# National Committee on Uniform Traffic Control Devices

# National Committee on Uniform Traffic Control Devices (NCUTCD) Recommended Changes to Proposed Text for 11<sup>th</sup> Edition of the MUTCD Docket Number: FHWA-2020-0001

Federal Register Item Number: 623-638

NPA MUTCD Section Number: Sections 9E.01-9E.17

Figure 9C-3. Word, Symbol, and Arrow Pavement Markings for Bicycle Lanes

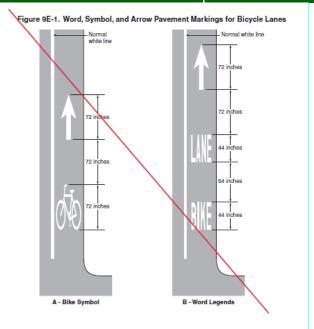
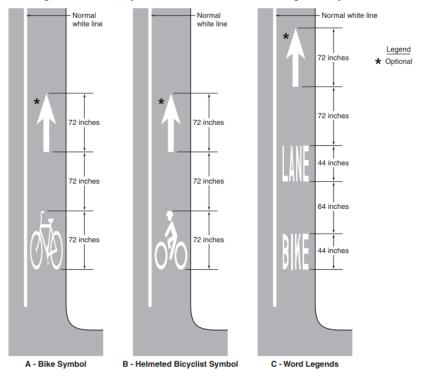
# NCTUCD recommends replacing Figure 9E-1 in the NPA with Figure 9C-3 from the 2009 MUTCD to include the bike lane pavement marking option depicting a helmeted bicyclist.

Figure 9E-3. Example of Bicycle Lane Markings on an Approach to an Intersection (Sheet 1 of 3)

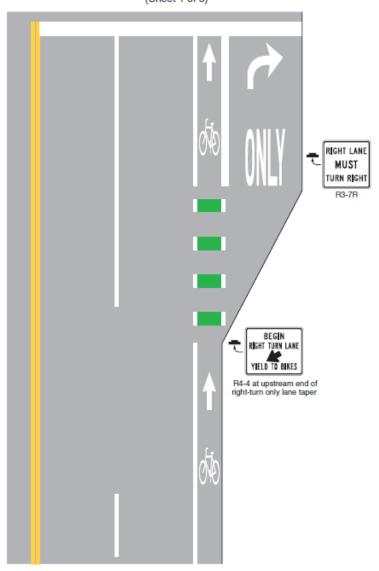
RIGHT LANE 50 ft MIN. MUST TURN RIGHT R3-7R revise straight arrow to left BEGIN RIGHT TURN LANE turn arrow R4-4

Figure 9C - XX. Example of Pavement Markings for Buffered Bicycle Lanes on a Two-Way Street

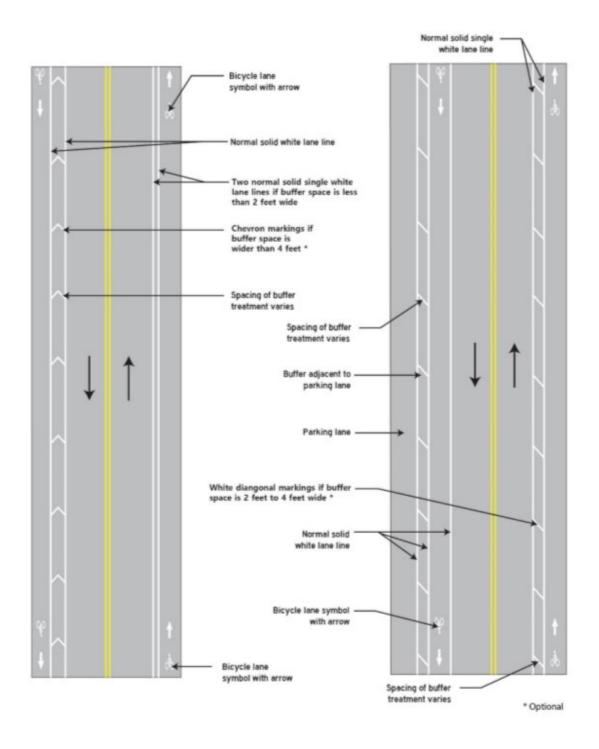
NCUTCD recommends replacing Figure 9E-6 as presented in the NPA with Figure 9C-xx from NCUTCD recommendation 18B-BIK-05 to better depict commonly-used markings for bufferseparated bicycle lanes.

Figure 9E-9. Example of Shared-Lane Markings on an Approach to an Intersection

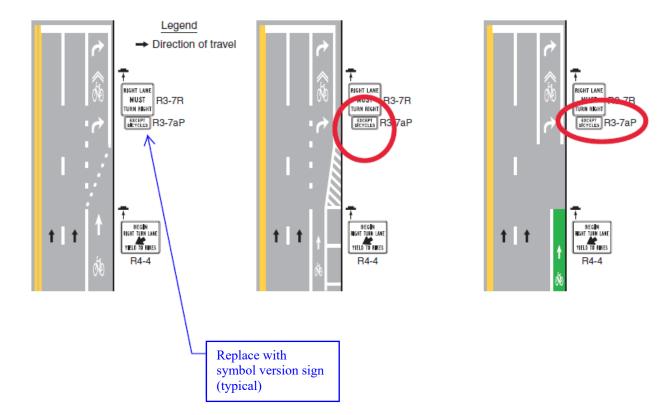
NCUTCD generally agrees with Figure 9E-5 as presented in the NPA, but recommends replacing R3-7aP EXCEPT BICYCLES plaques with the symbol version in accordance with NCUTCD recommendation 09A-BIK-01.

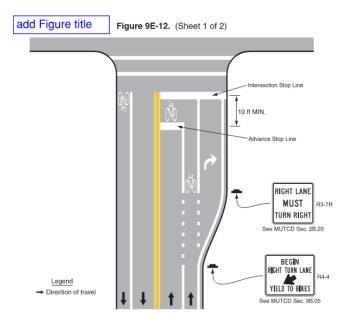
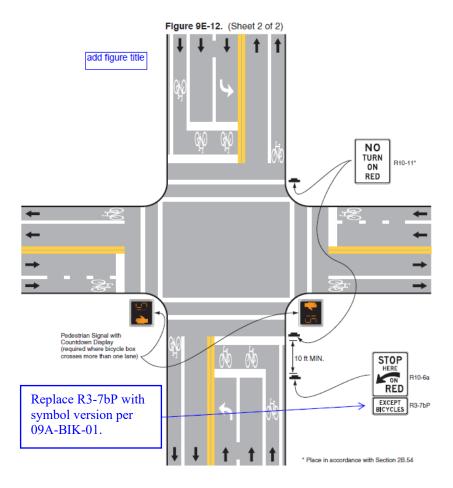
NCUTCD generally agrees with Figure 9E-12 as presented in the NPA, but recommends adding titles to figures and on sheet 2 of 2 replacing R3-7aP EXCEPT BICYCLES plaques with the symbol version in accordance with NCUTCD recommendation 09A-BIK-01.

Figure 9E-14. Pavement Markings for a Shared-Use Path with Mode Separation

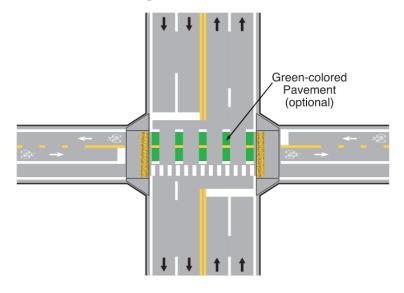
NCUTCD generally agrees with Figure 9E-14 as presented in the NPA, but notes the width of the crosswalk appears to be too narrow in the figure when compared to other markings.

Figure 9E-15. Example of Placement Route Markers for Shared-Use Paths

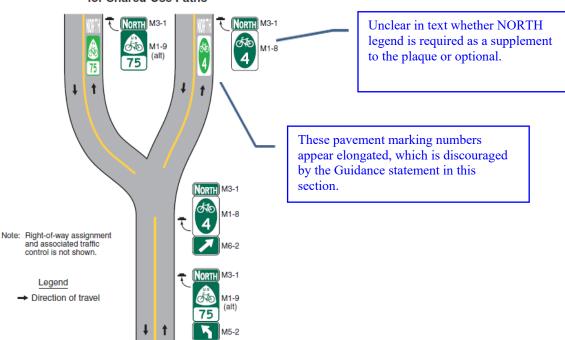
NCUTCD generally agrees with Figure 9E-15 as presented in the NPA, but notes that the pavement marking graphics appear elongated, which is not consistent with provisions in Section 9E-14. The figure is also unclear as to whether the cardinal direction marking is required or optional.
